# 1984 - 1990 Corvette: Service Bulletin: Underhood Lamps Inoperative or Staying On

**Bulletin Number:** 90-248-8B

**Date:** 05-07-1990

# Corvette Underhood Lamps

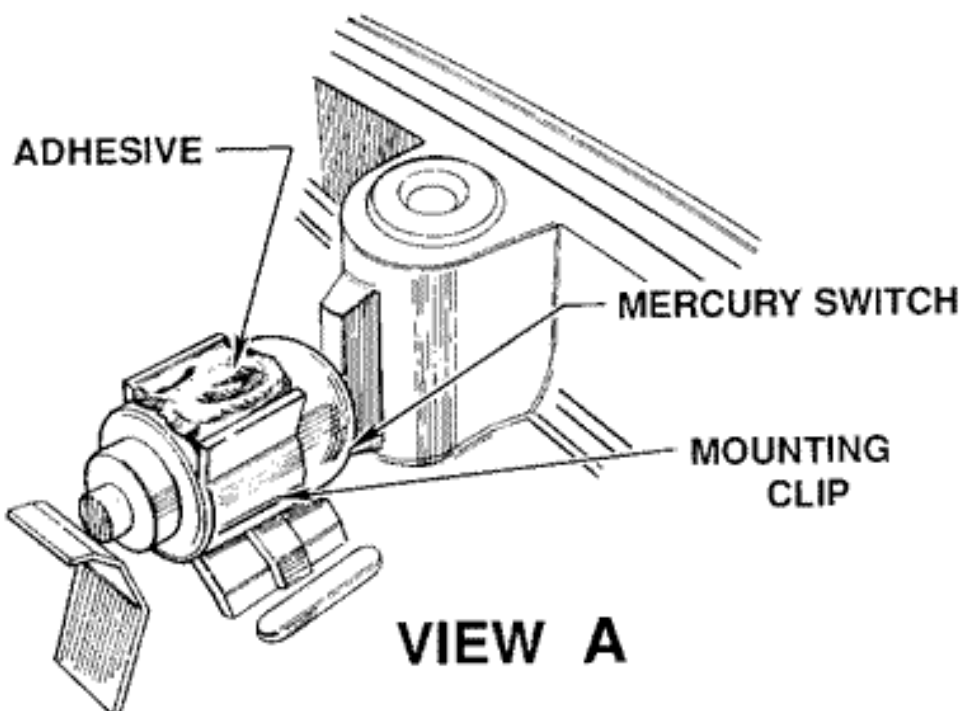
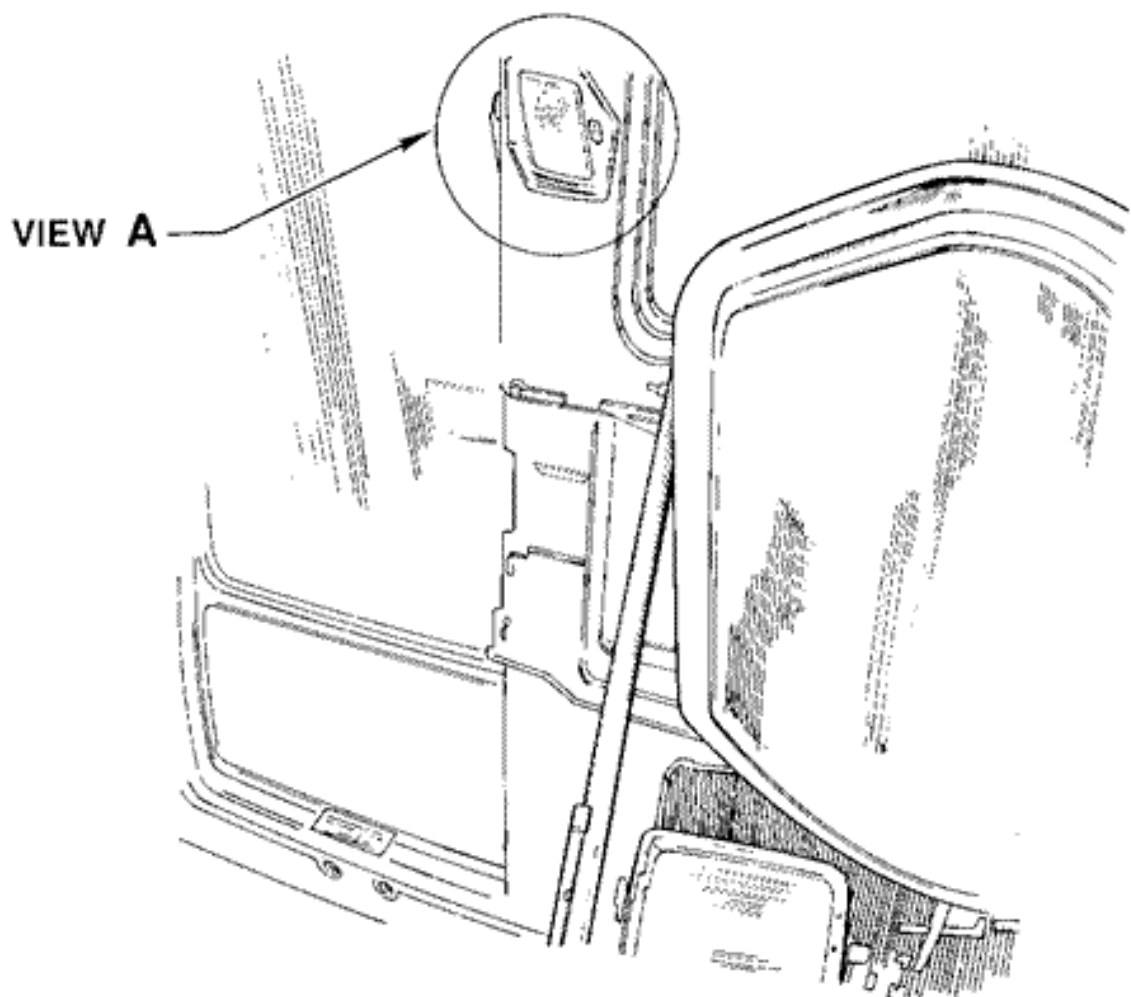
1. Mercury switch disengaged from retaining clip in lamp housing.
2. Mercury switch partially disengaged, and shorting across terminals.
3. Mercury switch has either short or open circuit internally.

**IMPORTANT: If lamps are still on with the hood almost closed, the mercury switch may be shorted. Replace the switch with P/N 16503204.**

5. Raise the hood to full open, and apply a bead of 3M #08670 T3 Silicone, Permatex #26B High Temp R.T.V. (or equivalent) across the switch and clip ends for retention as shown in the illustration.
